07.3-281 Renewing holder for fuel pump, fuel filter and fuel reservoir

Model 107

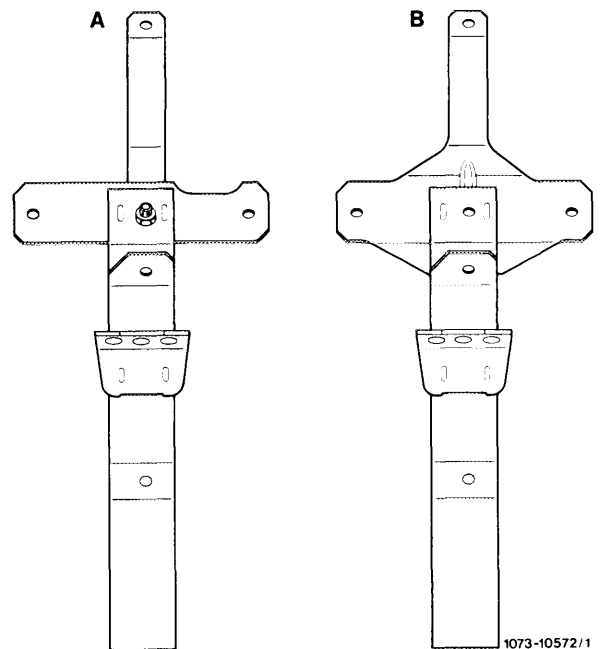
The holder has been modified to improve installation position and to increase rigidity.

A Former version
B Present version
